**PLANNING PERMIT – PA2403365  
SECTION 72 AMENDMENT APPLICATION  
NEERIM ROAD, MURRUMBEENA (Allotment 2012 East of Elsternwick, Parish of Prahra)**

Resultant from these changes in site context and the design review process, the following changes to the Planning Permit and associated approved development are sought as part of this application and as informed in the architectural plans prepared by *Fieldwork*:

**Figure 2 & 3: Comparison of northern façade between decision plans (top) and proposed amended plans (bottom), showing the increased level of the coloured streetwall, recession of the eastern frontage, and increased central visual break.**

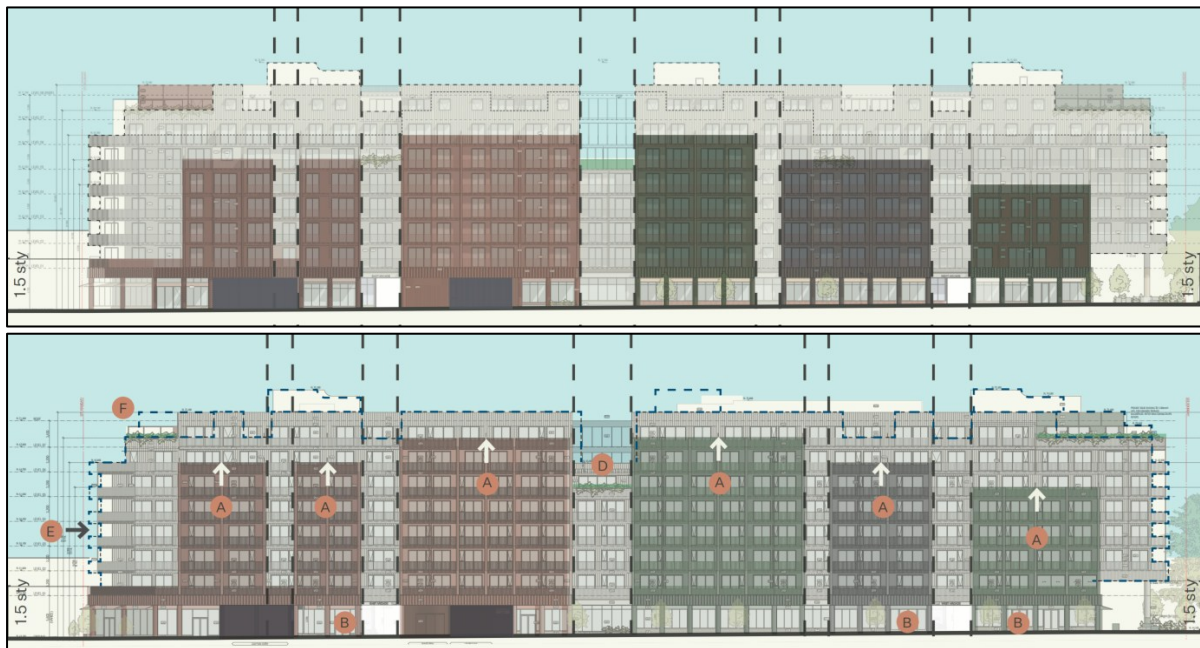
The amended façade treatment still carries the same rationale and relationship to the surrounding context, with materiality and form continuing to capture certain identified elements of this section of Murrumbreena with the more earthy, warm colour palette applied on the eastern side of the streetwall in appreciating the residential context nearby and further east, while more cooler and softer blues, greys and greens are applied to the western end contrasting these colours and appreciating the commercial context on this western side and northern side of Neerim Road. The accompanying material includes a Façade Strategy in response to Condition 5 requirements, which further details the design rationale and intent.

The upper-level presentation remains consistent with the approved design through selective use of colour and materiality to provide visual breaks and distinction across the span of the built form in response to the Site's noted constraints. The stepped design of the coloured streetwall elements is increased in height by one level, whilst maintaining the stepping down towards the east and west edges of the form. Additionally, the central visual break between the two 'wings' of the form is increased in width slightly. A comparison of the current and amended designs is provided in Figures 1 and 2 below.

The amended street front presentation and façade detailing maintains the positive attributes of the original approval, including the material reference to the adjoining existing residential neighbourhood and commercial shopfronts, and articulated design to break up the span of the built form. The increase in the level of the streetwalls is mitigated by the variation in height and colour between each section and retained recessions between each streetwall element. These reveals define each component into varied clusters, with the revised balustrade detail providing a more open appearance and reducing the built form solidity.
